ADDENDUM #3

CITY HALL HVAC UPGRADE

BID #14/15-008 – PWP# WA-2015-012

**SPARKS CITY HALL
 CAMPUS HVAC UPGRADE
 SPARKS, NEVADA**

ALTERNATE #3

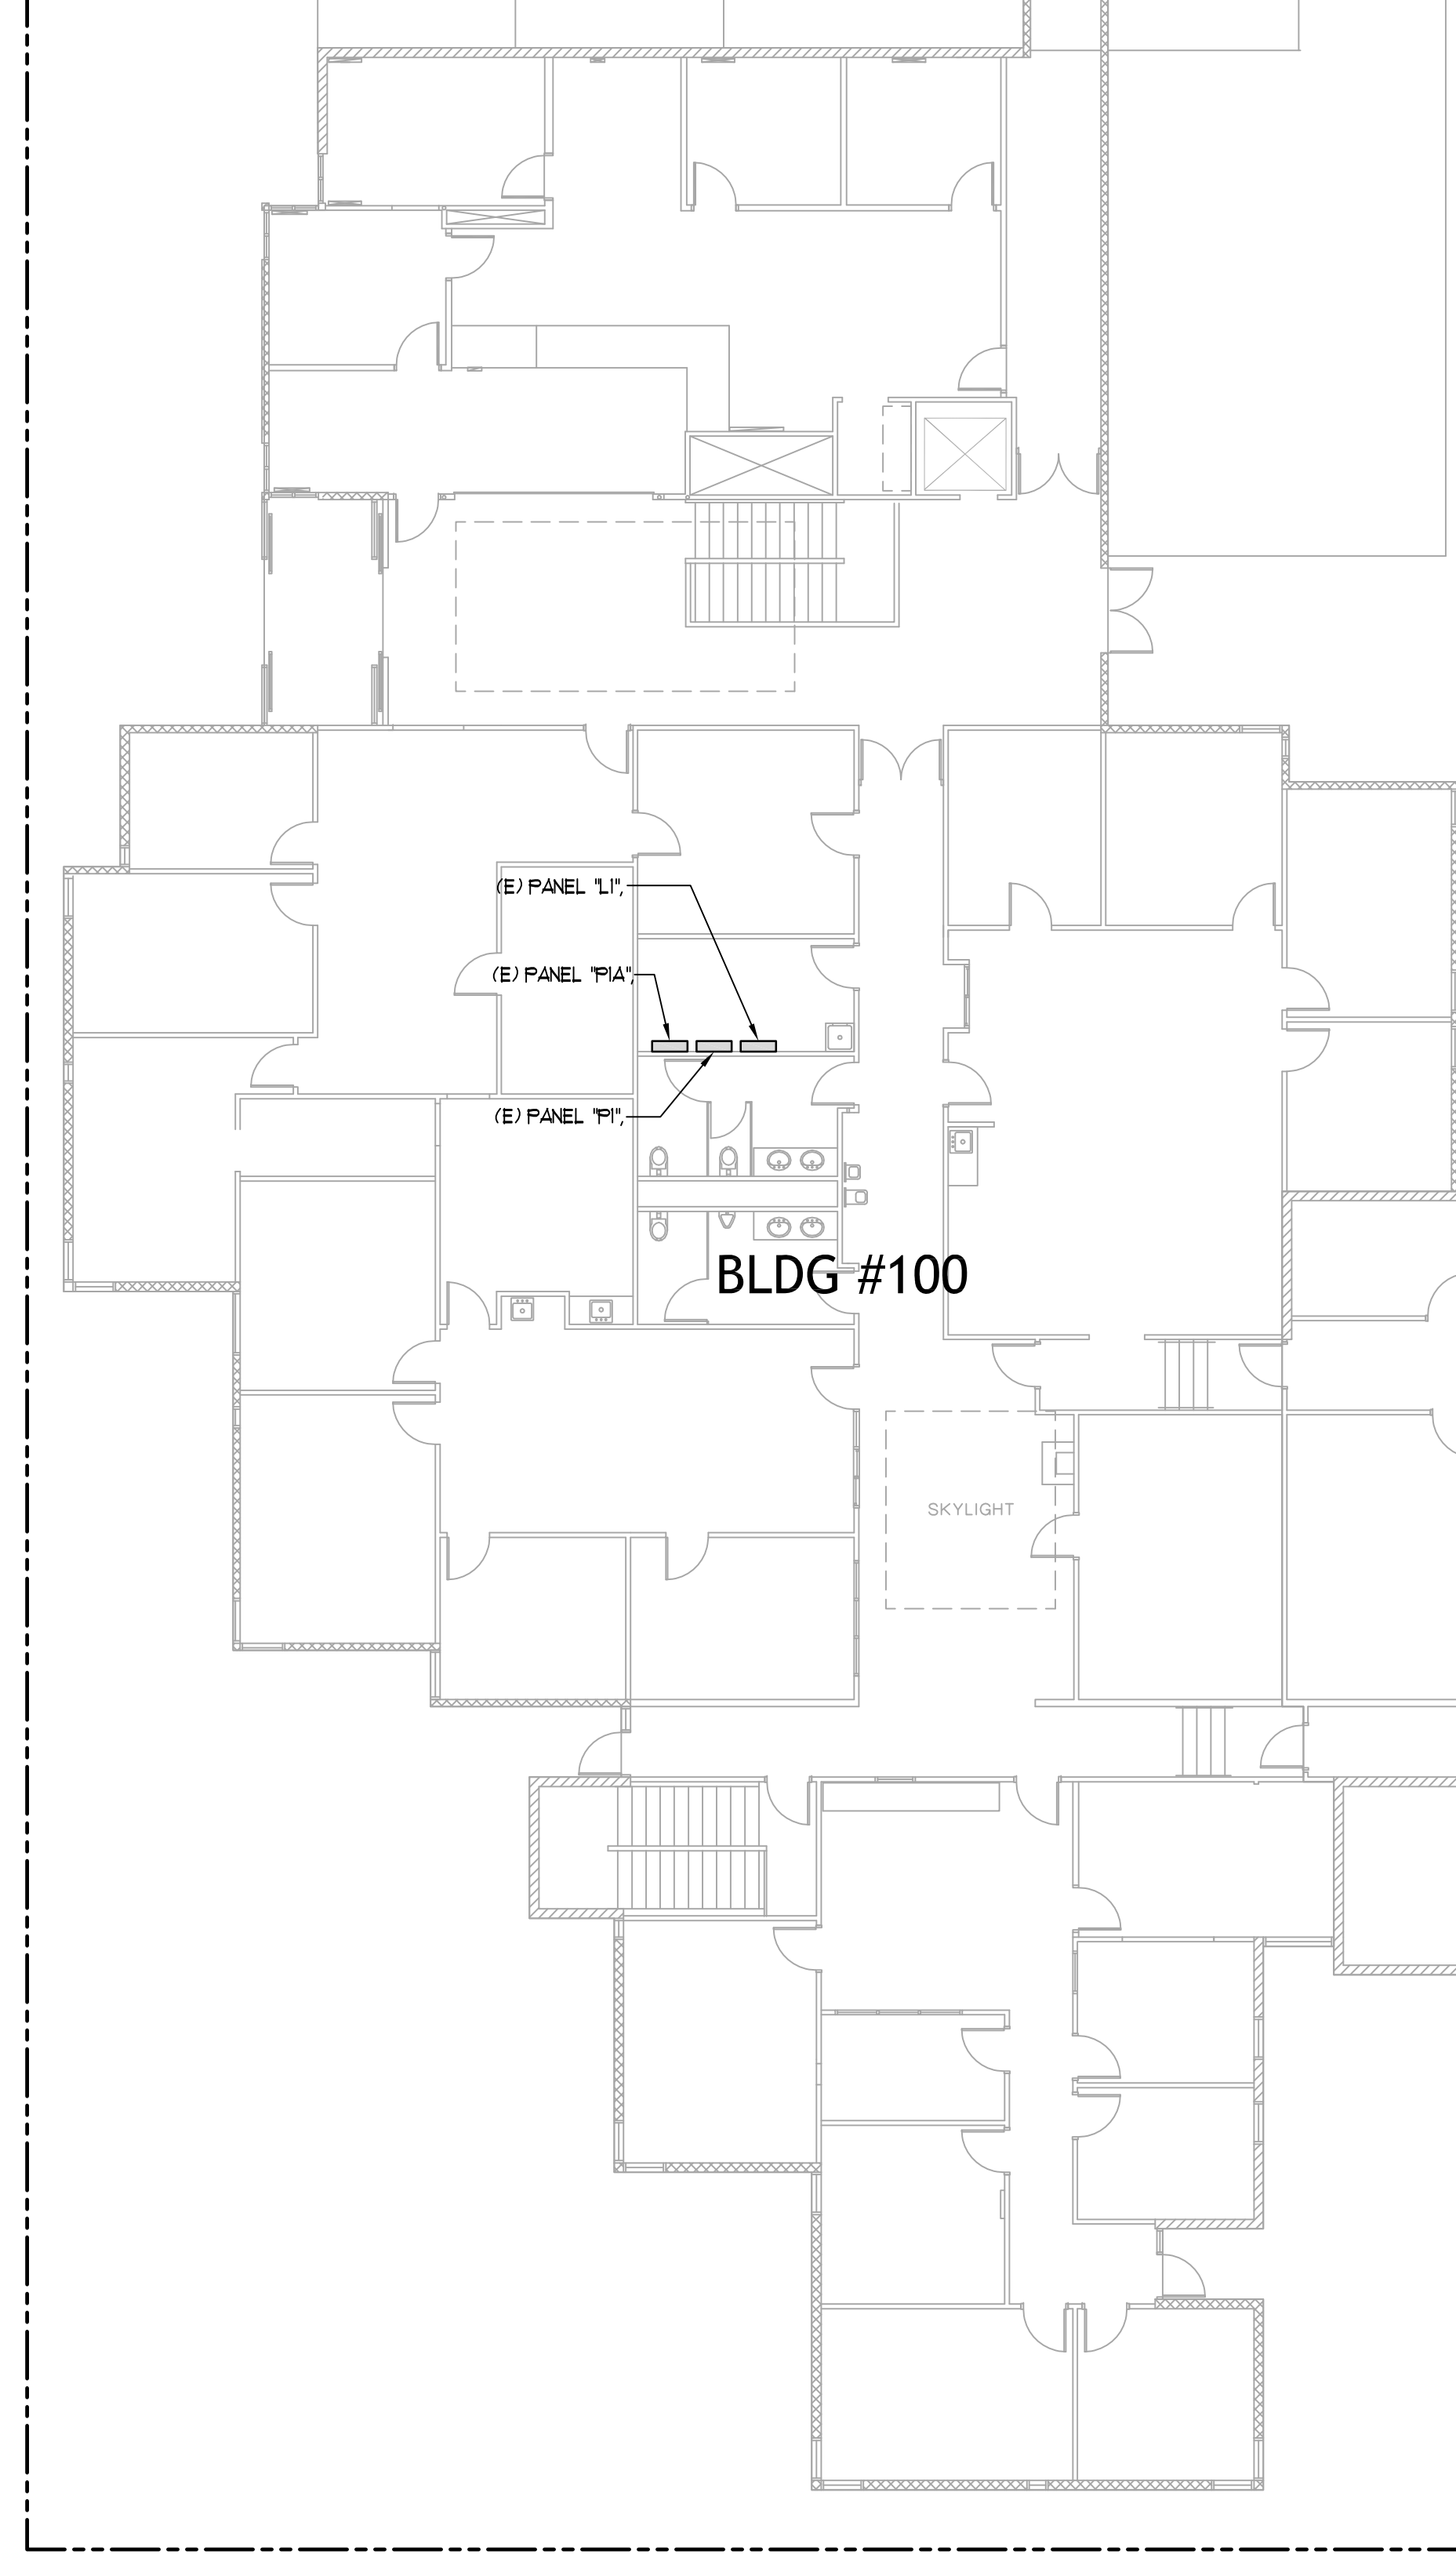
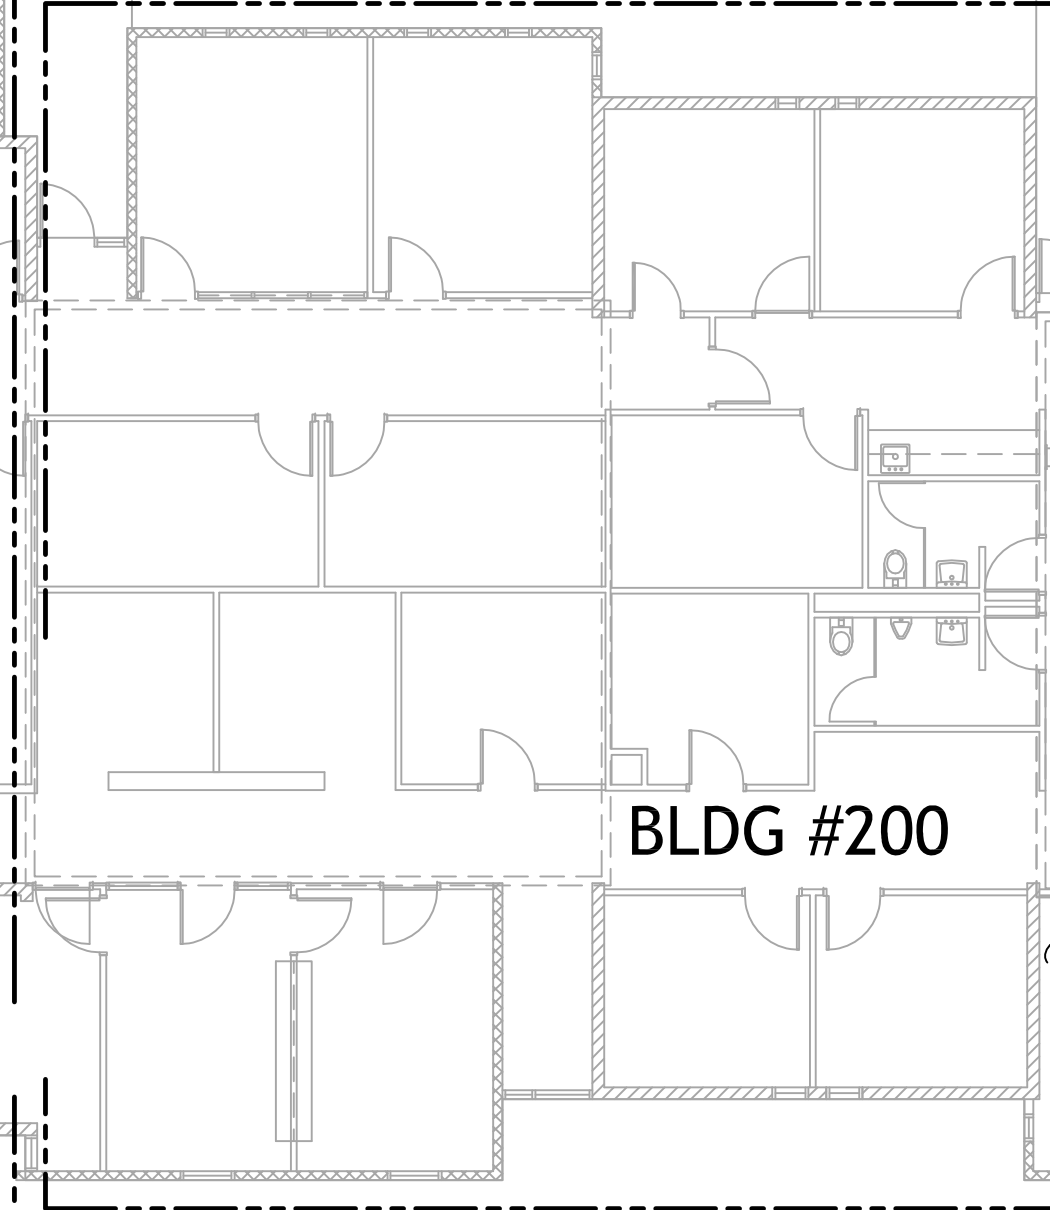
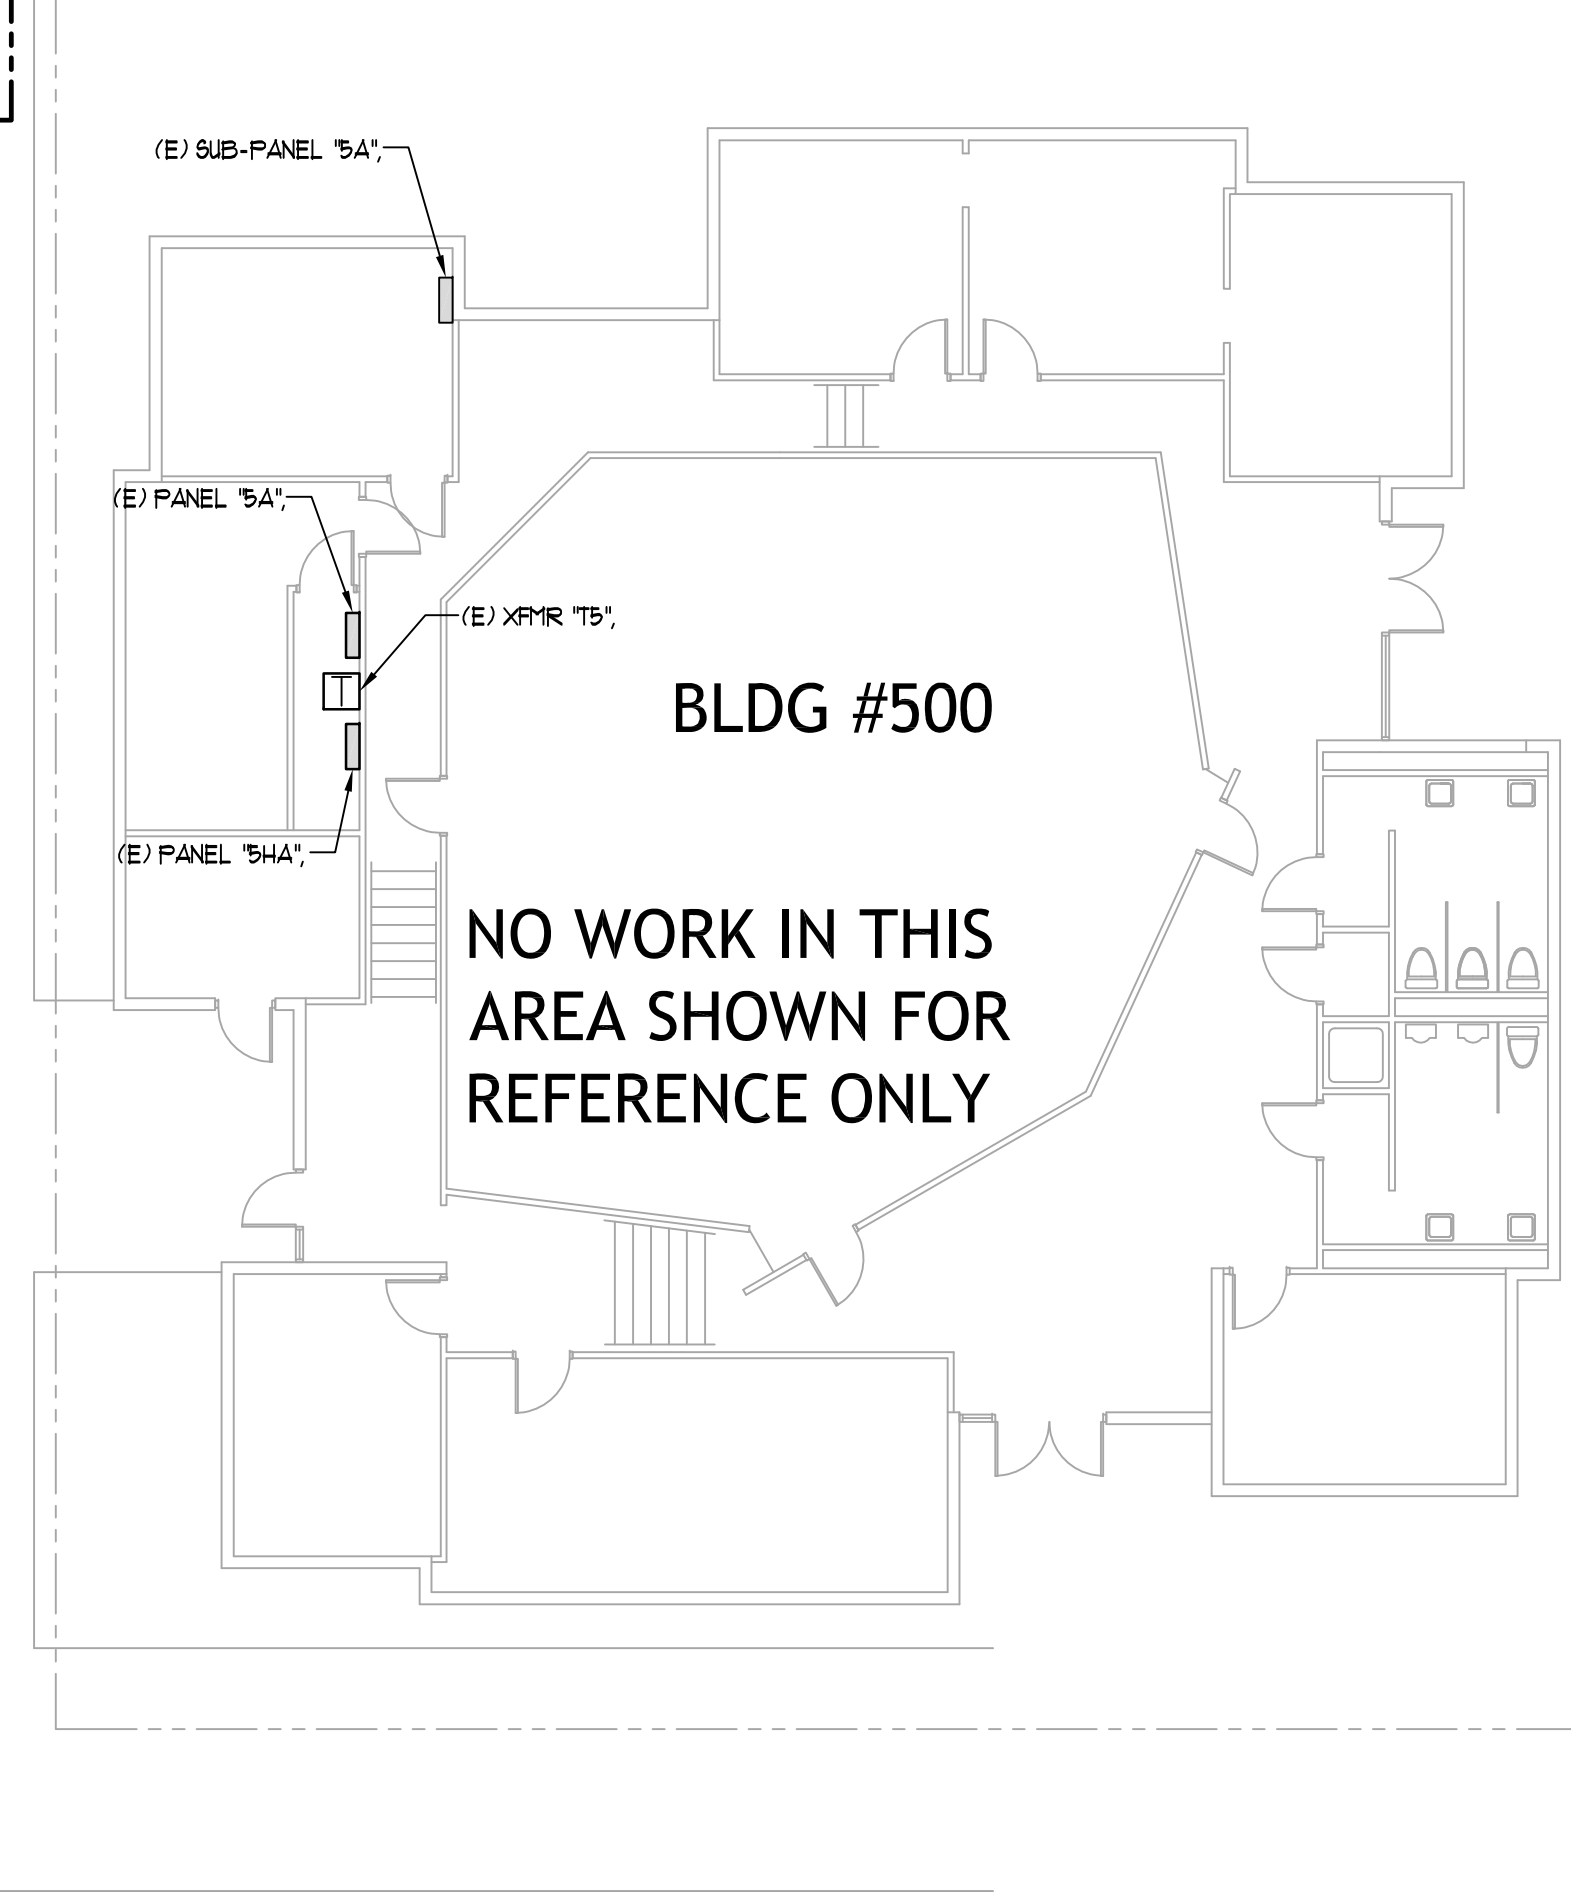
IF ALTERNATES #1-#4 ARE NOT ACCEPTED THEN AHU'S WILL REMAIN CONNECTED TO EXISTING MCC.

- Ⓢ ELECTRICAL CONTRACTOR TO DISCONNECT ALL ELECTRICAL CONNECTION TO MECHANICAL EQUIPMENT. CONDUCTORS TO BE REMOVED BACK TO PANEL CONDUIT TO BE REUSED. CONTROL WIRING REMOVAL TO BE COMPLETED BY MECHANICAL'S CONTROLS CONTRACTOR.
- Ⓢ ELECTRICAL CONTRACTOR TO DISCONNECT AND REMOVE ALL CONDUCTORS AND CONDUIT TO PANEL. (IF ALTERNATES 1-4 ARE NOT ACCEPTED THEN THE AIR COMPRESSOR WILL BE RELOCATED AND RECONNECTED)
- Ⓢ RELOCATE BOILER SHUT DOWN SWITCH. SEE SHEET E1.3 NOTE 3 FOR NEW LOCATION.
- Ⓢ IF ALL ALTERNATES ARE ACCEPTED THEN MCC WILL REMAIN OPERATIONAL DURING CONSTRUCTION AND WILL BE REMOVED AFTER ALL EQUIPMENT CONNECTIONS ARE DISCONNECTED FROM MCC. REMOVE MCC FEEDER AND EXPOSED CONDUIT WHEN MCC IS REMOVED.
